City of Portland, Maine - B	uilding or Use	Permit Applicat	tion P	ermit No:	Issue Date:	CBL:		
389 Congress Street, 04101 Tel				09-0996		013 K0	52001	
Location of Construction:	Owner Name:		Own	er Address:		Phone:		
28 NORTH ST	CAROLAN JO	OHN D	28 1	NORTH ST				
Business Name: Contractor Name		e:	Cont	tractor Address:		Phone		
	Portland Reno	ovations	111	Anderson Stre	et Portland	20771235	2077123590	
Lessee/Buyer's Name Phone:			Per p	nit Type: 1427 / S Iditions - Multi	Family		Zone: R-b	
Past Use:	Proposed Use:		Pern	nit Fee:	Cost of Work:	CEO District:	7	
3 Unit Residential	3 Unit Resider	ntial - remove existi	ng	\$270.00	\$25,000.00	0 1		
		nterior walls & tos siding demo others	FIRE DEPT: Approved INSPE		PECTION: Group: RZ	Type: 52		
lesalus	r - 3d.v.		*	See Cond	itions	TB(-70	BC-2003 ature: MB10/13/0	
Proposed Project Description: remove existing gable roof & inter histor than existing.	PE		PEDESTRIAN ACTIVITIES DISTRICT (P.A		nature: MBU T (P.A.D.) d w/Conditions	AŭD.) / /

#### Ann Machado - RE: 28 North Street

#### Jeanie Bourke - 28 North Street Residence

28 North Street Residence

#### Drawing S-3:

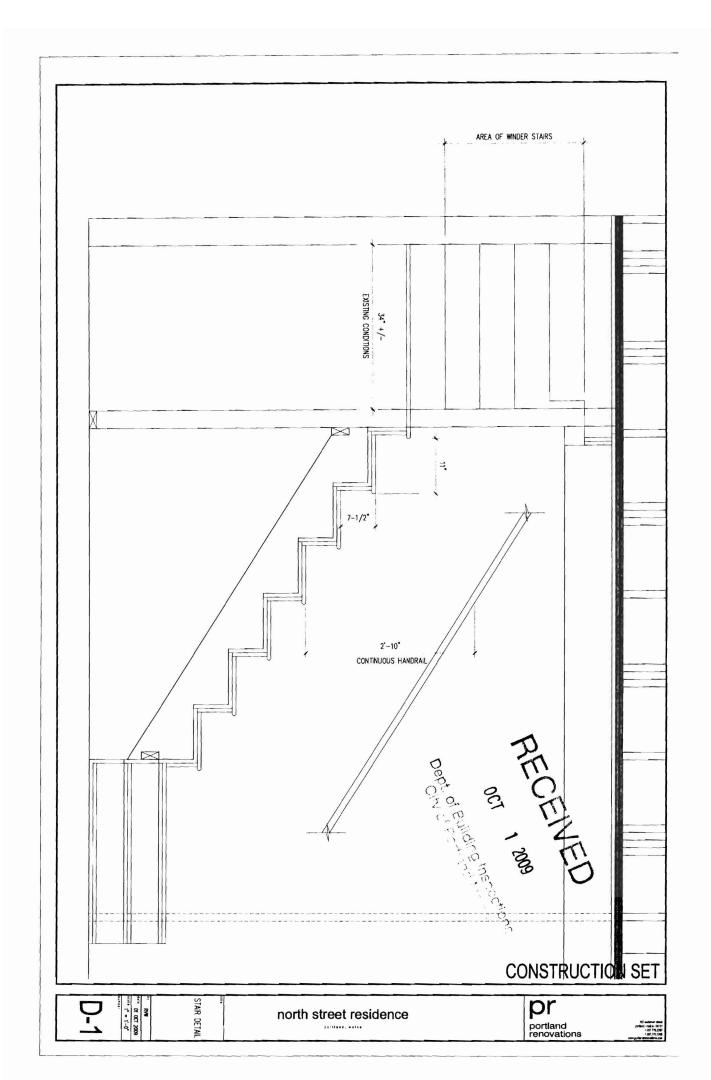
S-3 is another Site Plan showing the building and it's property line in relation to Sumner Court and the existing building to the west, to address the fire concern. To that, the area of the glazing surface of each Paradigm DH 2466 on the west elevation we're proposing to install is 3.63 S.F. per sash.....(17-3/8" X 30-1/8" per sash)....times two equals 7.26 S.F....this is for **one** window unit. There are 5 windows proposed for that elevation....times five equals **36.30 S.F**.. The total square footage of the western wall (not including the tails of the rafters (that's cheating) is 289.31 S.F.. 15% of that is **43.39 S.F**. Hence, we meet the code requirement of 15% of the wall area. I realize this is just a number I have provided you with, so if you would like verification of the window glazing area, call Applicator's Sales where they have a record of the project under Portland Renovations, project name "North Street". Their telephone number is 207.797.7950.

Do I calculate the 15% based on the new work area or the entire third floor apartment? Related to that, do I calculate the roof area facing Summer Court for the new work area due to the fact that it will be a vaulted ceiling and is "space" for the fire to be?....sort of the wall albeit, it's the roof. If the wall, and therefore a portion of the roof were required to be fire rated based on the distance to the PL this would be true, but this distance relates only to percentage of allowed openings.

To that: the wall and vaulted ceiling space (flat elevation square footage) on the Sumner Court side is 518.95 S.F., 15 % of that is 77.84 S.F.. The new sliding door and window glazing proposed in the new work on that side is a total of 40.47 S.F.. If we calculate it based upon the entire third floor, which makes perfect "code sense", we probably only have 5% glazing surface, there are only two small windows in a dormer on that side (image attached). It's a bit more complicated....see Sec. & Table 704.8 of IBC 2003. and Table. The code requires calculating the sf of the new wall area of the 3rd story wall and the percentage of proposed glazing, roof pitches are not considered walls.

If I understand correctly, we're fine on that side. Actually, if the distance is 10' or less it would be 10%....the plot plan shows 10'. Please propose a waiver to the code to allow for the fire separation distance to be calculated based on the distance of the adjacent structures or to the required setback if no structure exists. Include all of the calcs to substantiate this and the % of proposed openings, protected and unprotected as the case may be. Remember, <15' allows 15% unprotected and 45% protected.

- The percentage of wall opening allowance is based on the distance to the property line or midline of the ROW as follows: >5' to 10' = 10%, >10' to 15' = 15%. Fire glazing can be used for a portion of the openings to achieve the above percentages.
- This means that the wall facing Sumner Ct. will need to be calculated for percentages at the 15% allowance. It appears the rear gable wall falls under the 10% allowance.
- On the revised site plan, the stair direction configuration is shown as being the same as the existing stairs. Is this changing?
- If the stairs are part of the 3rd floor unit (which I believe they are) the stair tread run can be a net 10" instead of 11" if that helps with spacing.

#### Drawing D-1:

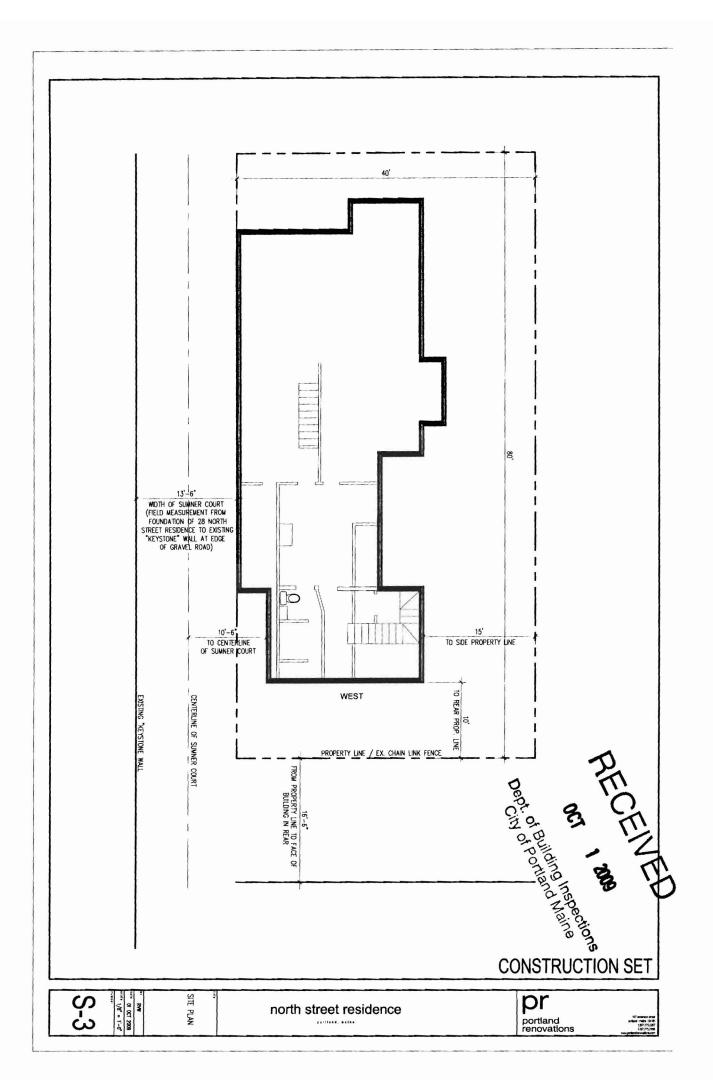
D-1 is a detail drawing of the stairs. The result will be a 7-1/2" rise with a 11" run for all steps in the renovation (same proportion as the existing conditions). The winders will not comply with the 6" minimum run at the inside of the step due to existing conditions which we are constrained to due to existing stairwell widths which we will be building upon.

The revised site plan is showing the third floor existing conditions, my apologies, I should have labeled that. Yes, the stairs are part of the third floor unit but an inch doesn't do much for us, it's all about head room above the opening below these stairs. 11" treads work nicely for the stairs that are straight, the quick rising turn at the winders needs the 10". Ok, the rise and run is ok, but the new configuation should be reflected on the plan.

#### Fire Separation Summary:

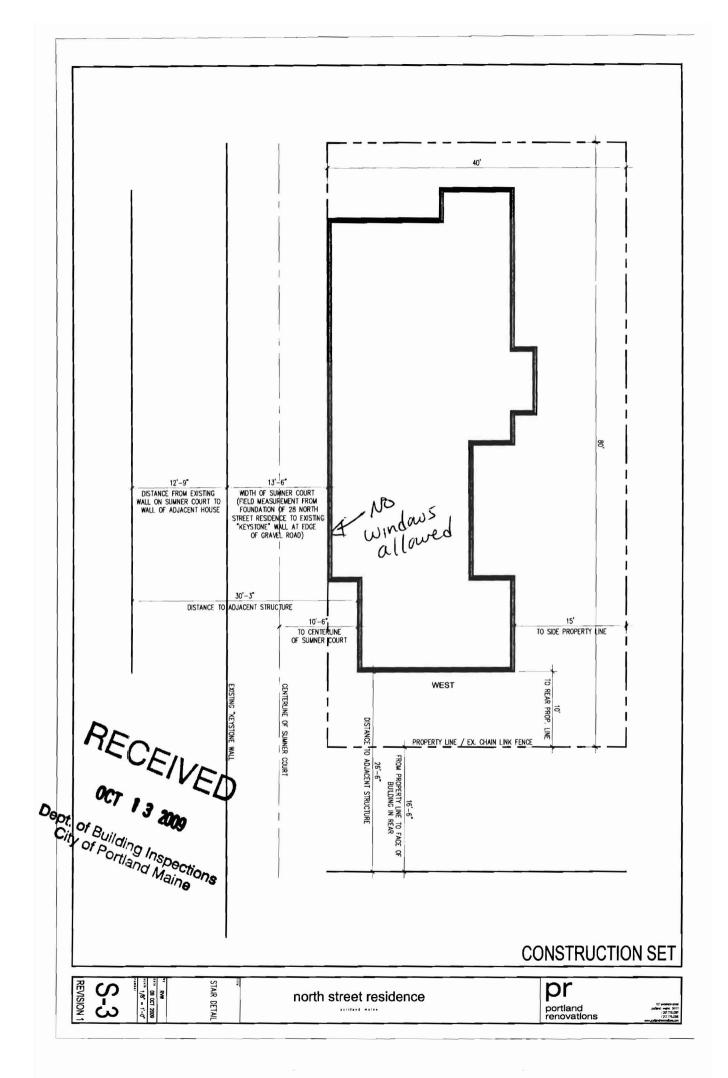
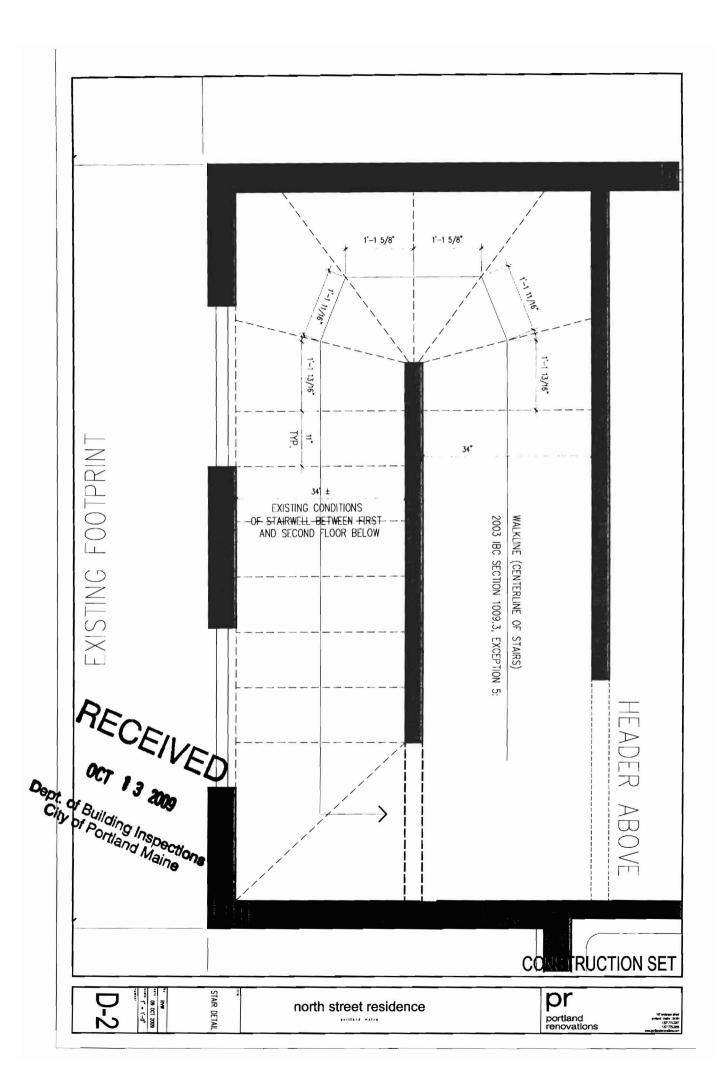
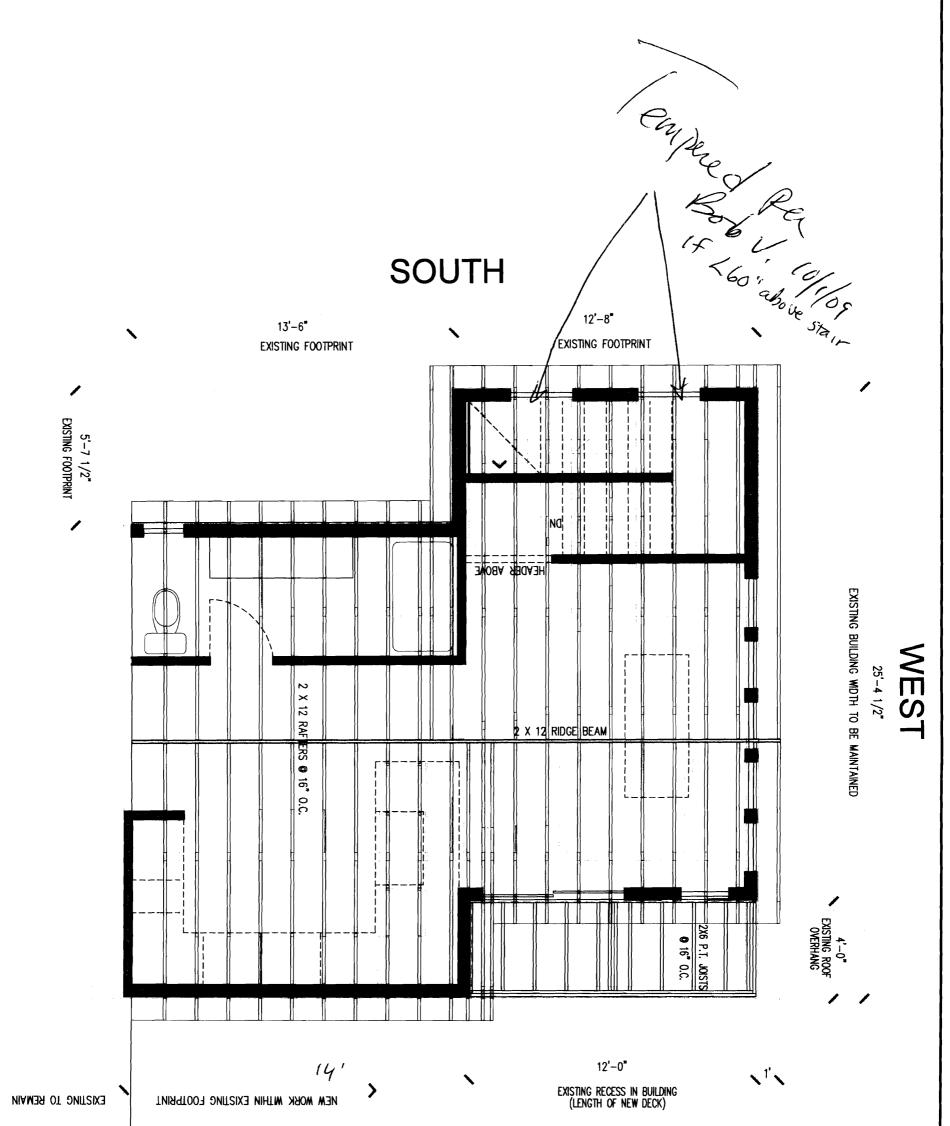
Attached please find drawings D-3 and S-3\_rev.1. D-3 shows the plan of the winders you requested. I trust that my previously submitted drawing D-1 showing the elevation of the stairs is still sufficient. The revised drawing S-3 shows the adjacent property on the Sumner Court side at a distance of 26'-3" from our property.

In regards to my calculation of the area of the glazing on the Sumner Court side (shown in the thread below), accounted for the entire width and length of the slider. If I take into account the 3" stile width for the sliding portion of the door and the fixed portion of the door in the middle of the entire door, that's roughly 3 S.F. which changes the area of glazing on that side to a total of 37.38 S.F..

We are proposing a waiver to the code to calculate our available unprotected glazing surface to be determined by dividing the distance between adjacent structures by two. If I interpret correctly, Table 704.8 states that if the distance (for unprotected openings) is between 10 and 15', the allowable area of opening is 15%.

Not ever 14' of wall 13.14 West Elevation (back of building) Distance to adjacent structure: 26'-6", divided by two = 13'-3". Wall area: 289.31 S.F. Glazing area: 36.3 S.F. 15% of wall area: 43.39 S.F. North Elevation (Sumner Court side) Distance to adjacent structure: (30'-3") divided by two = 15'-1-1/2" (actually puts us in the 25% limit by 1-1/2") Wall area: 269.39 12' portion of well @ slider is 12'HT 14' portion is 8' Glazing area: 37.38 S.F. 15% of wall area: 40.40 S.F. 25% of wall area: 67.34 S.F.

= $15D$ f = 161 $f = P_{1}2f$ $320 \cdot 25$	CONSTRUCTION SET		
		north street residence	
SEP 1 7 2009	ī	WEST ELEVATION	
DRIVEWAY	n	<sup>y</sup> RVW <sup>sto</sup> 17 SEPT 2009 <sup>csto</sup> 1/4" = 1'-0" unber A-4

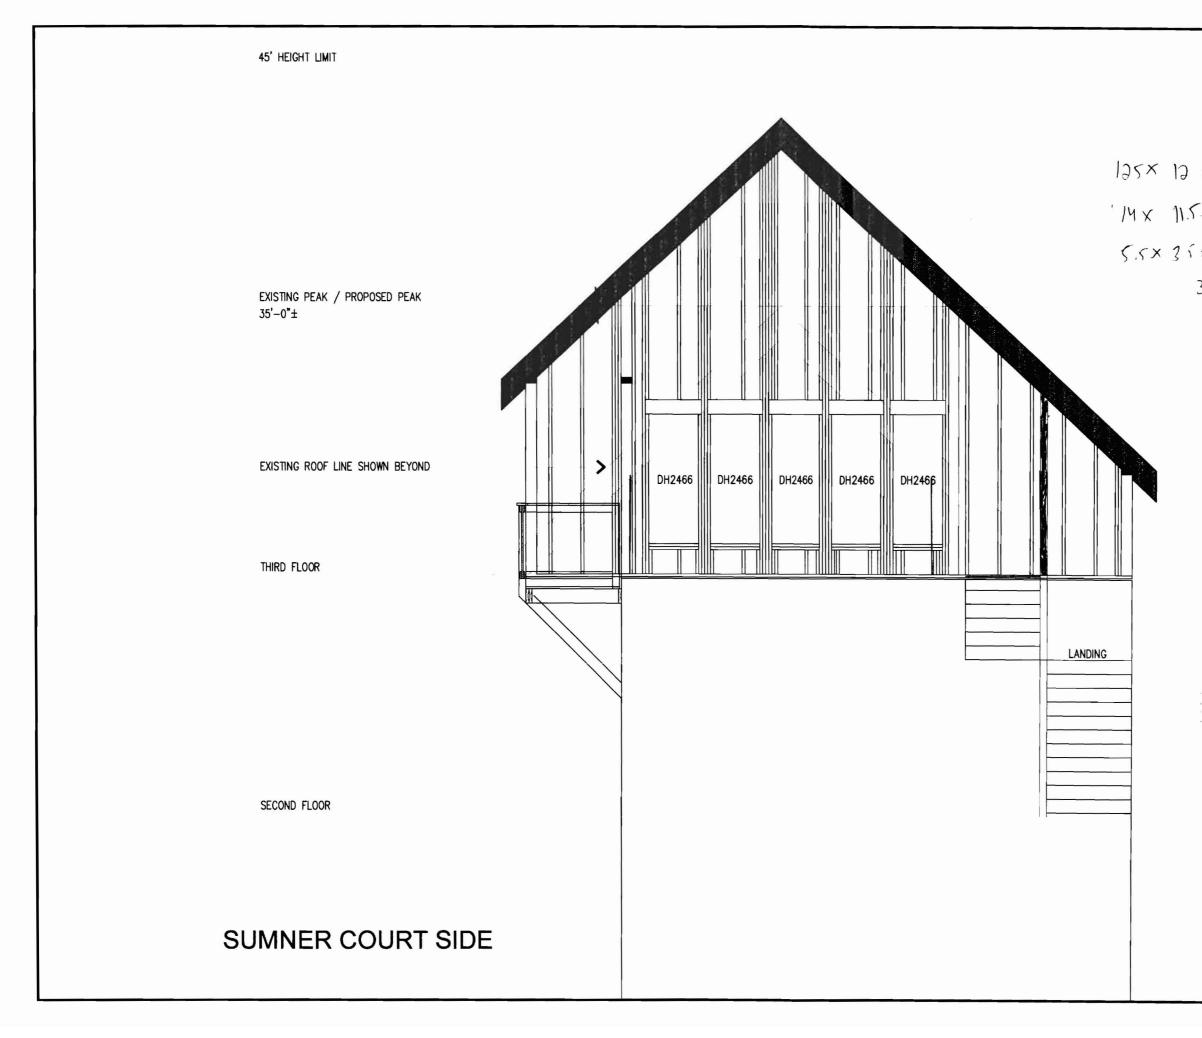
Attached is a drawing depicting what the west elevation of the project would look like if we are forced to comply with section 14-436b of the city ordinance.

Obviously this would make an enormous structure standing about 8 feet taller than the existing building. While buildable, it presents a few financial barriers for the reality of the work as well as continued safety hazards that currently exist.

As for the safety hazards, there is currently a problem with ice and snow falling from the roof of the existing gable roof that falls onto the entry for two of the units there. The proposed design sheds the snow and ice melt toward Sumner Court where it is plowed away and does not fall on people or create icy conditions on the porch below the roof. If we are forced to comply with the ordinance, we'll need to install unnecessary snow guards to make an attempt to prevent the inevitable.
